WALMART SUPERCENTER

ONLINE PICKUP DELIVERY EXPANSION

SITE DEVELOPMENT PLAN

PCD FILE # COM2612

DEMOLITION
PLAN

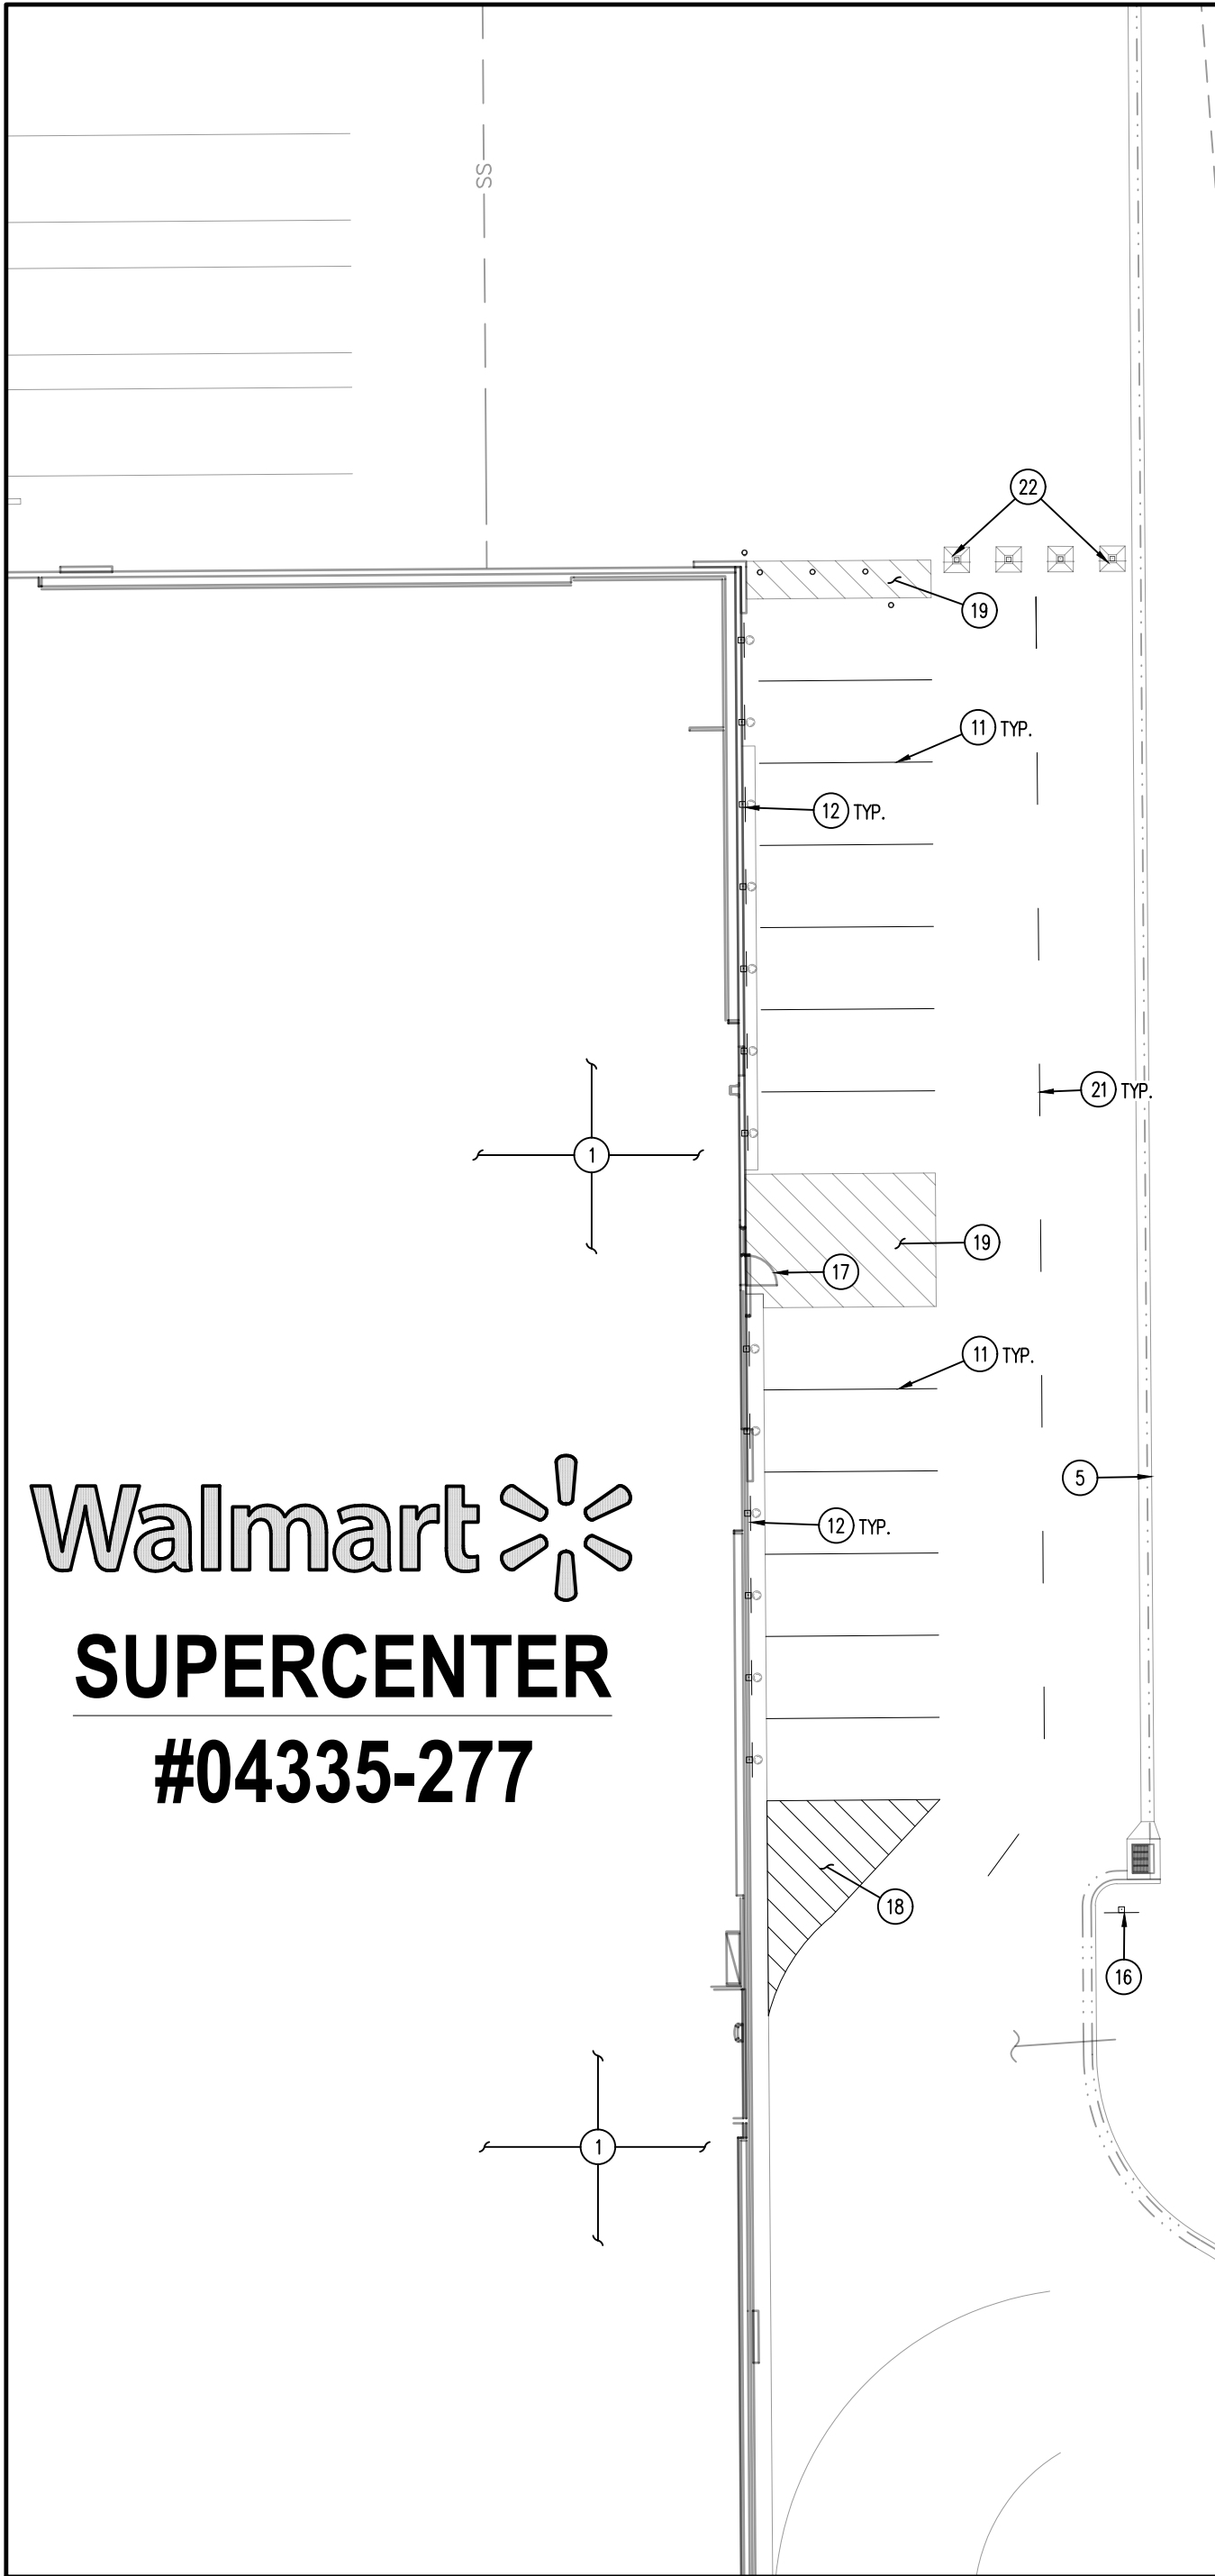
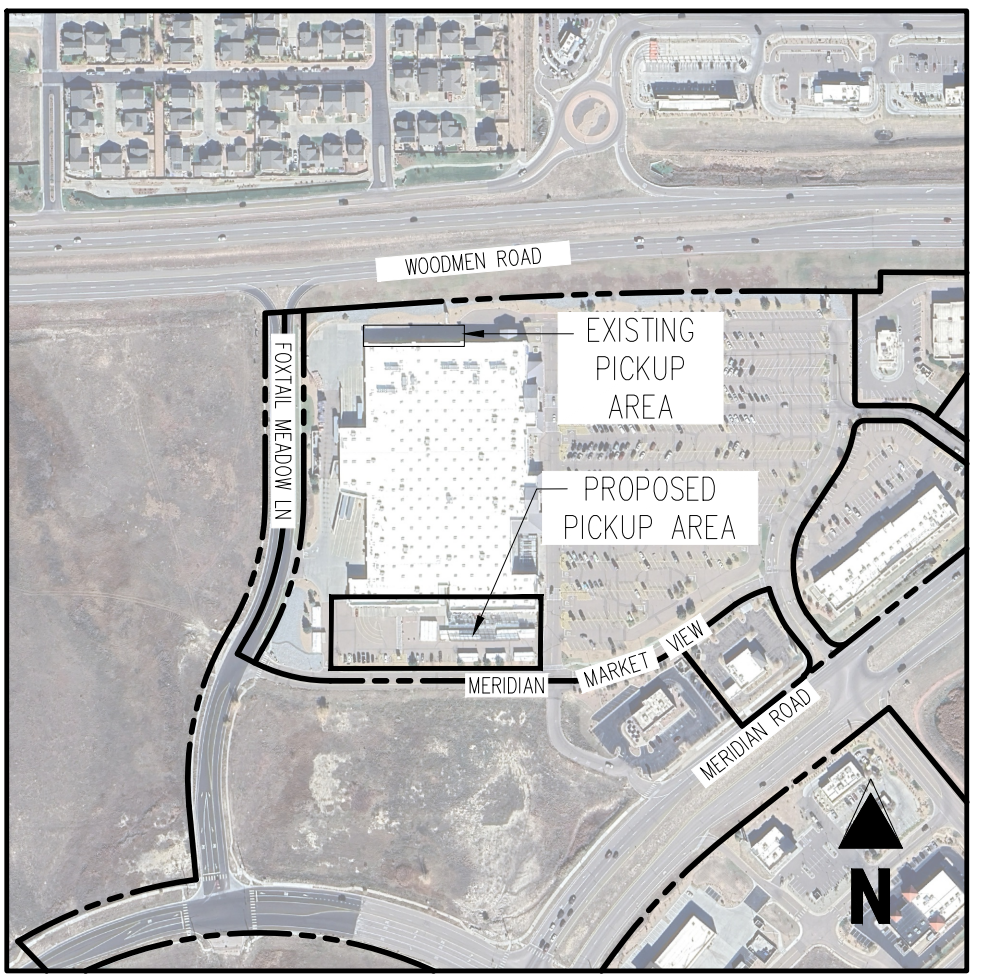
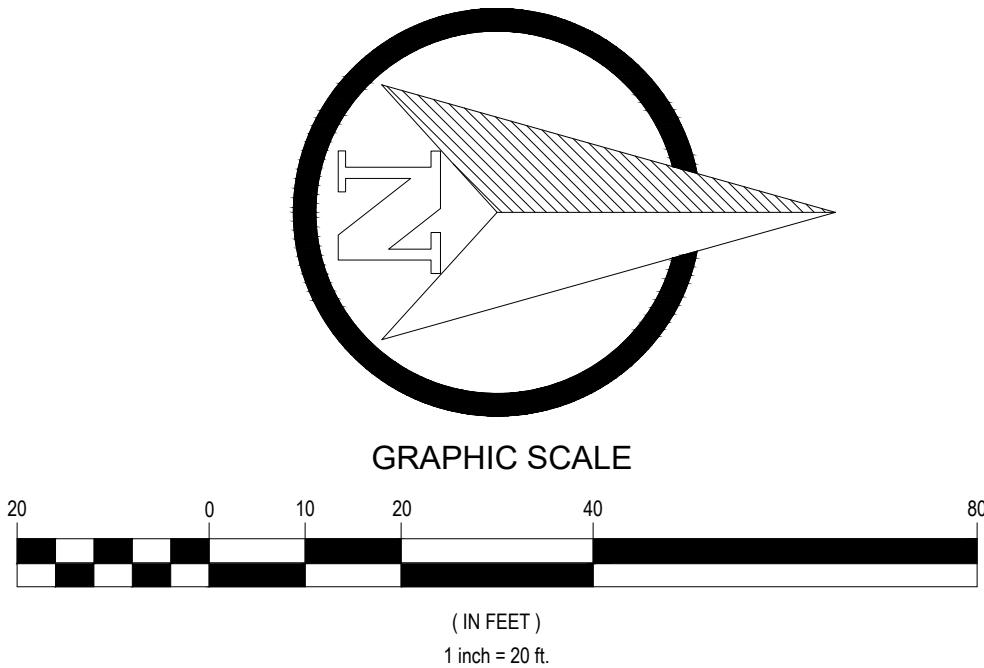
previous comment not addressed -
there is no City of Falcon, it should
be El Paso County
